SURFACE TRANSPORTATION BOARD
Washington, DC 20423

Office of Environmental Analysis

Re: Docket No. FD 35852, Canaveral Port Authority — Construction and Operation Exemption — Rail Line Extension to Port Canaveral, Florida; Information Request #2

Proposed CCAFS & SR-528 Rail Alignments

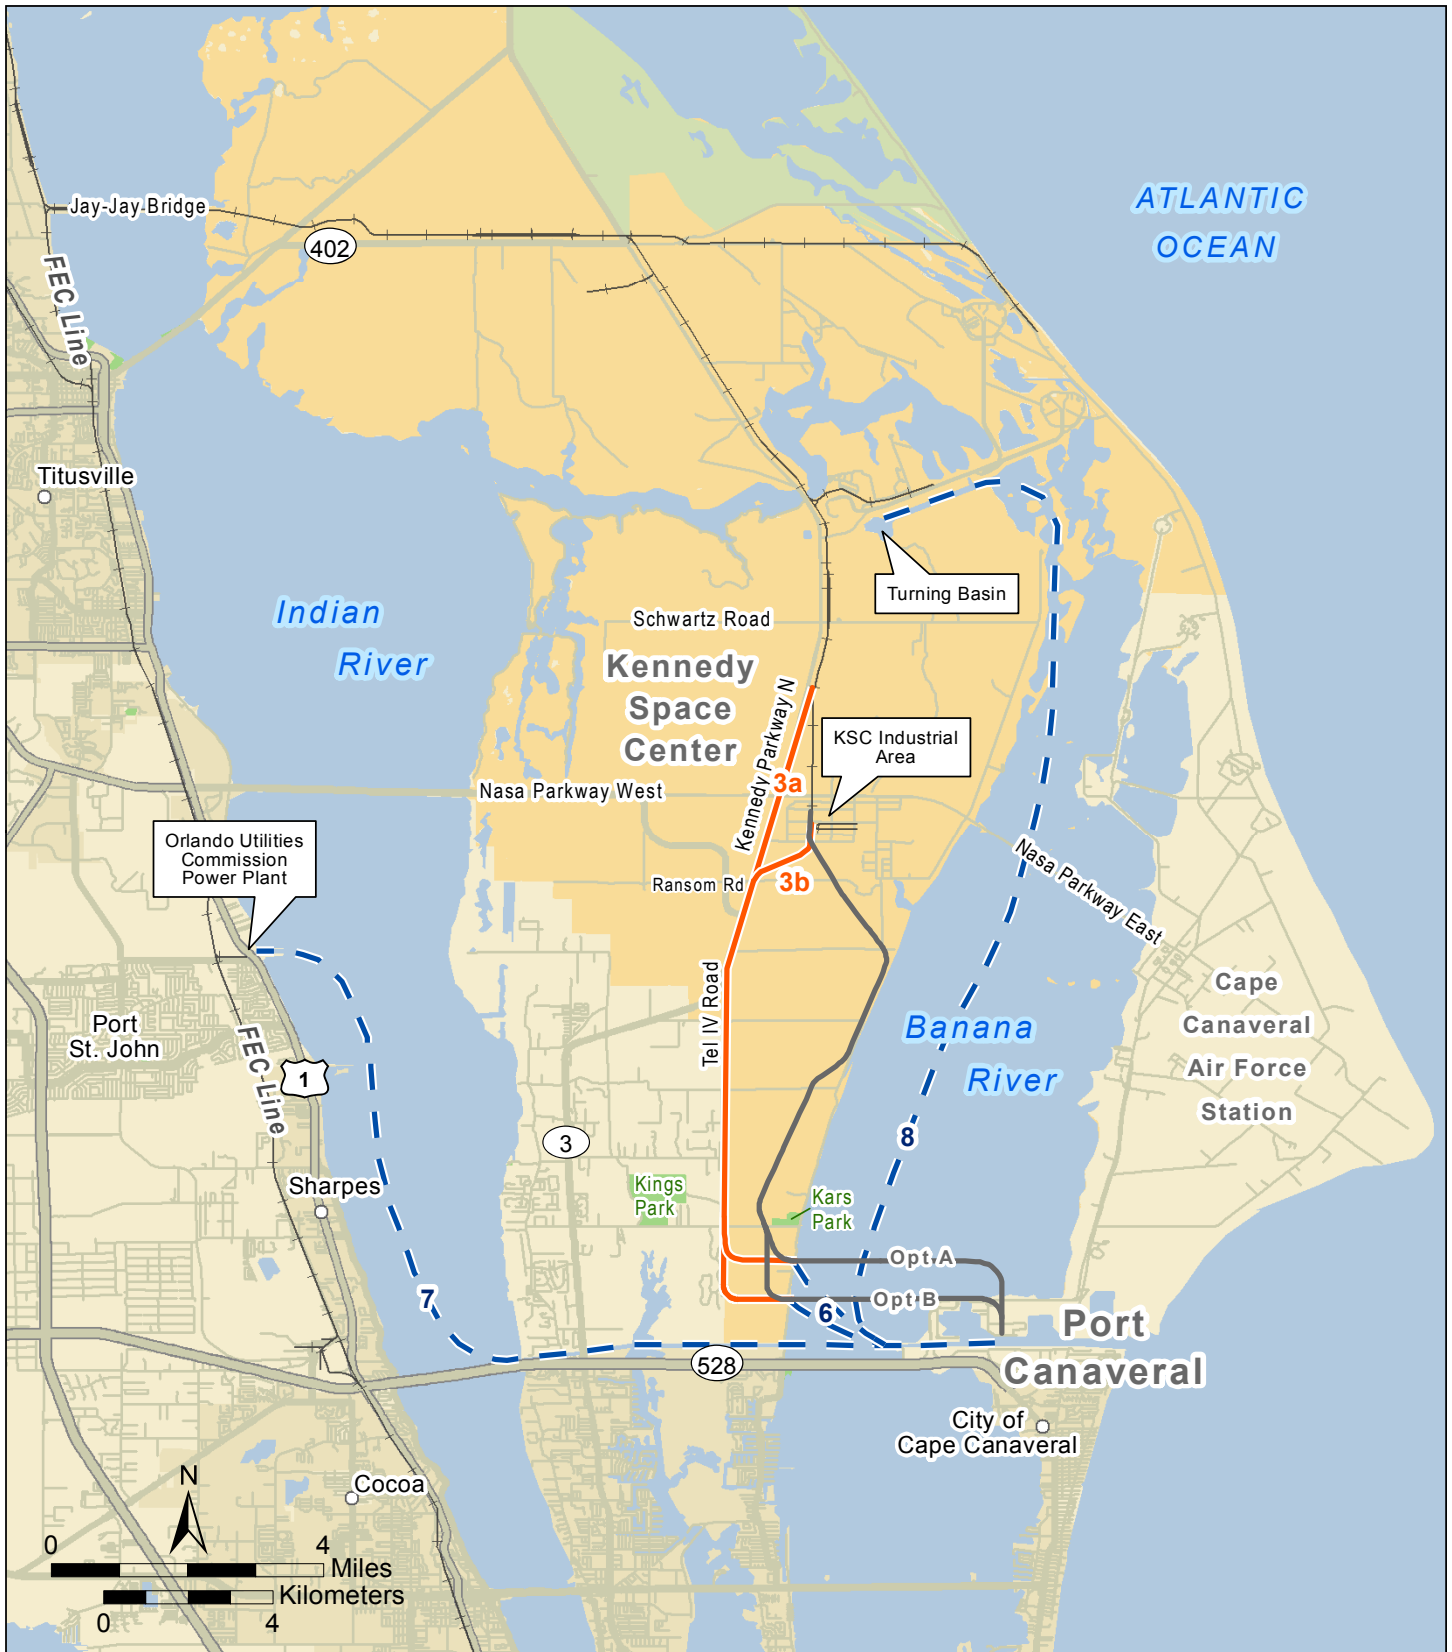
1. A number of scoping commenters proposed alignments that would cross the U.S. Air Force Cape Canaveral Air Force Station (CCAFS). They include the following proposed alignments (see enclosed figure, *Proposed CCAFS & SR-528 Rail Alignments*):
 - a. An alignment that would travel north through the CCAFS to the Launch Complex (LC)-39 Pad Area and connect with the National Aeronautics and Space Administration (NASA) Kennedy Space Center (KSC) rail line in that area.

- b. An alignment that would travel north through CCAFS and would depart CCAFS on NASA Parkway East, which it would follow until joining the existing rail in KSC.
- c. An alignment that would travel north through the CCAFS, specifically along the western shoreline of CCAFS, until leaving the CCAFS along the southern shoulder of NASA Parkway East.
- d. An alignment that would travel north through CCAFS via alignments 1b or 1c, and at the industrial area would turn west and leave the KSC along NASA Parkway West to the existing Florida East Coast Railway (FEC) main line.

Please provide any available written documentation concerning CCAFS's position on having the proposed rail line extension located on CCAFS grounds.

2. A number of commenters proposed alignments that would generally follow State Road (SR) 528. These include the following proposed alignments (see enclosed figure, *Proposed CCAFS & SR-528 Rail Alignments*):

- a. An alignment from the Port, following SR-528 until reaching the existing FEC main line.
 - b. An alignment that would run due west from the Port, parallel to the barge canal to the Indian River, then parallel to SR-528 at the Indian River crossing until reaching the FEC.

Proposed Tel-IV Road Rail Alignments & Barge Options

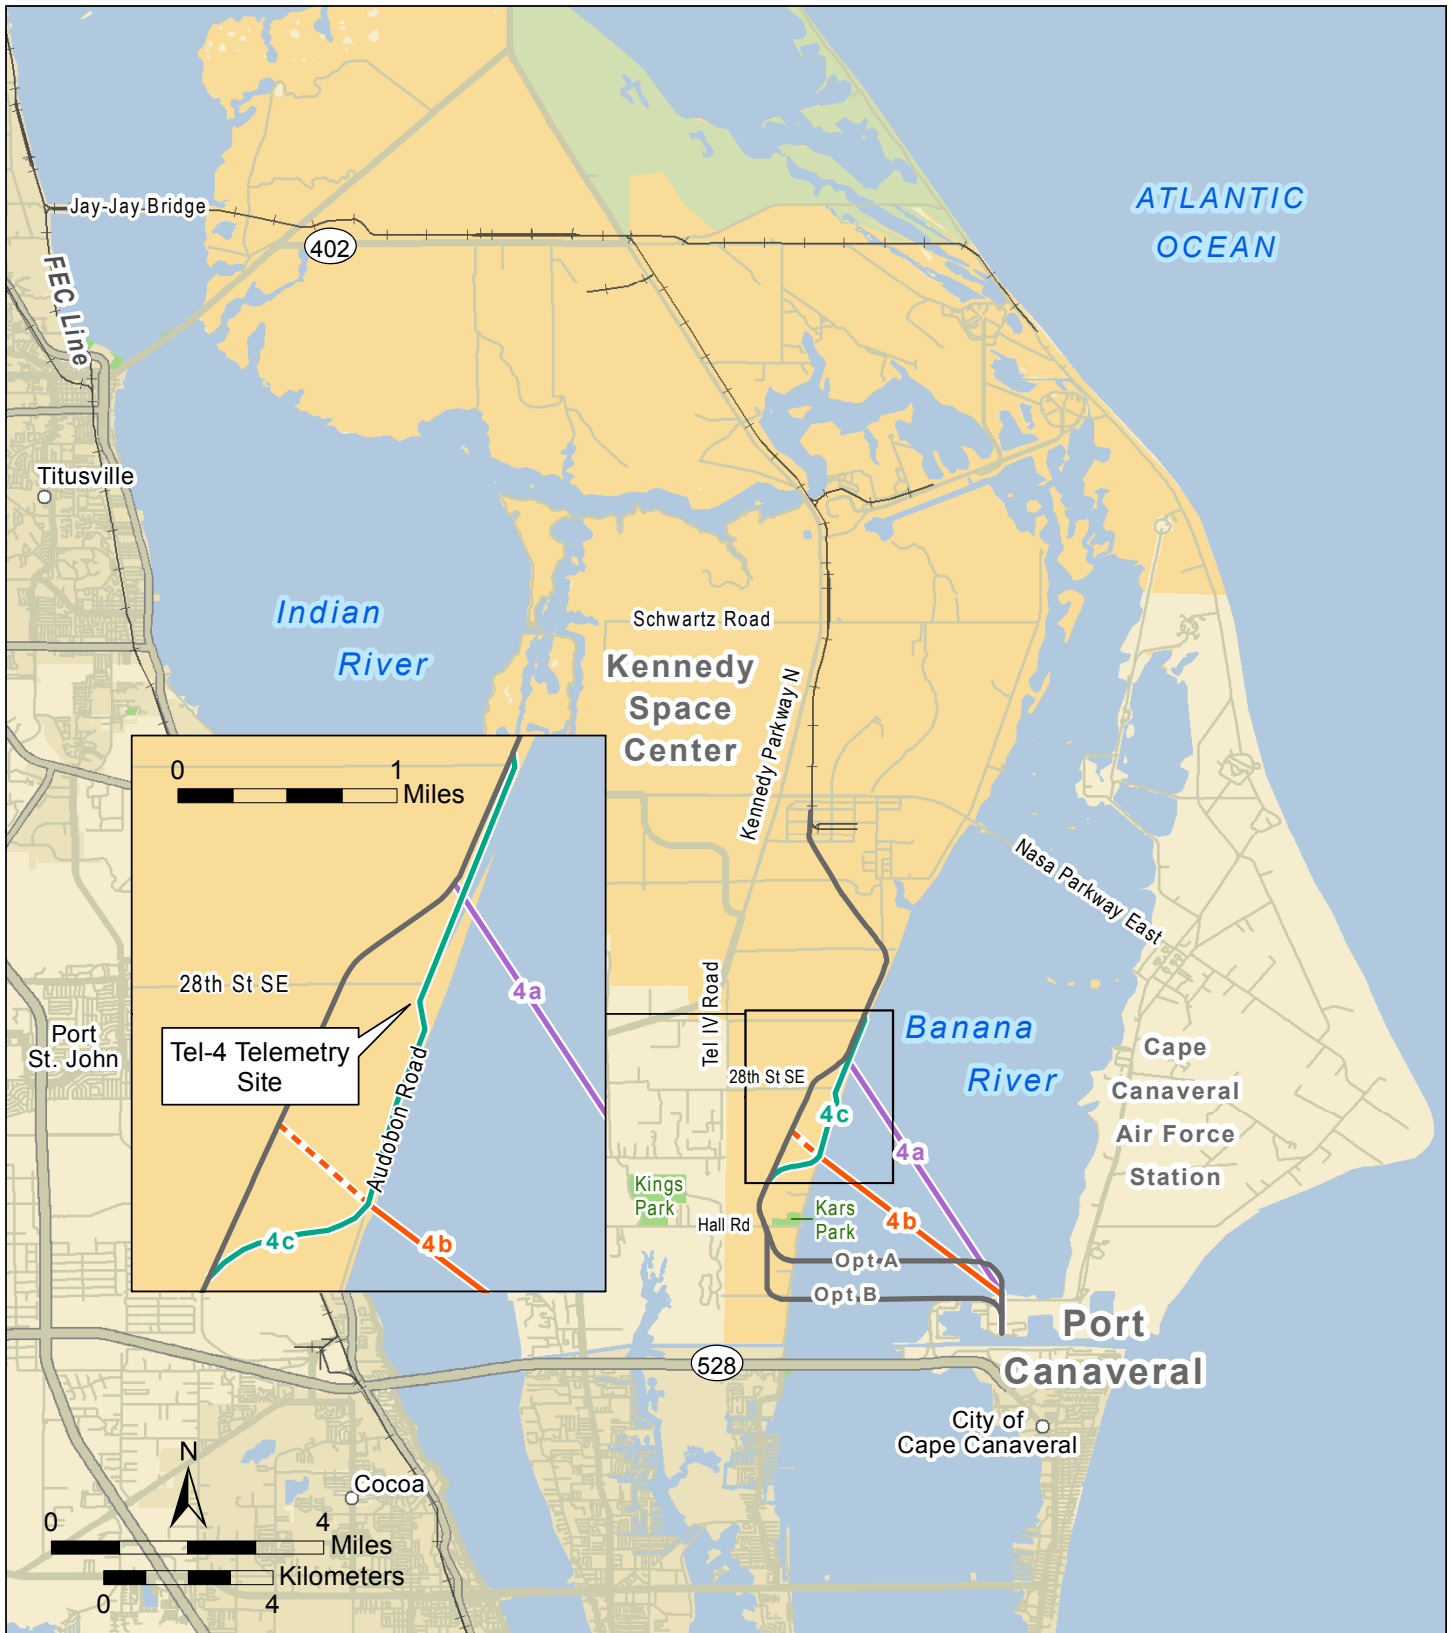
3. Scoping commenters proposed alignments that followed Tel-IV Road within KSC property. These included the following proposed alignments (see enclosed figure, *Proposed Tel-IV Road Rail Alignments & Barge Options*):

- a. An alignment that follows a route nearly identical to either Option A or Option B; but after crossing the Banana River, travels farther west and turns north to follow the western edge of the KSC property along a north-south line parallel to Tel IV road. The alignment would travel north until reaching Kennedy Parkway North, which it would follow until joining the existing KSC rail line.

- b. An alignment identical to 3a above, but after passing north of Ransom Road, turning northeast away from Kennedy Parkway North and meeting the existing KSC rail line in the KSC industrial area.

In addition to the rail alignments identified above, the evaluation of rail by barge options were proposed during the scoping period. For the rail by barge options described below, please state whether CPA considers the options listed below as being feasible or infeasible (see enclosed figure, *Proposed Tel-IV Road Rail Alignments & Barge Options*). For every option that CPA believes to be infeasible, provide a detailed explanation as to why it is considered infeasible.

6. An option utilizing rail by barge from the Port, across the Banana River to a point near where Option A or Option B is currently proposed to enter KSC property, then following the proposed rail options from that point.
7. An option utilizing a rail barge service that would include a rail transfer bridge at the Port and barge service to an inland port at the Orlando Utilities Commission’s Power Plant on the Indian River at Port St. Johns.
8. An option that would use rail by barge from the Port north through the Banana River, and through the barge canals to the turning basin near the existing rail line.
9. For all prior alignments examined by CPA, please describe in detail the screening process used to review these alignments.
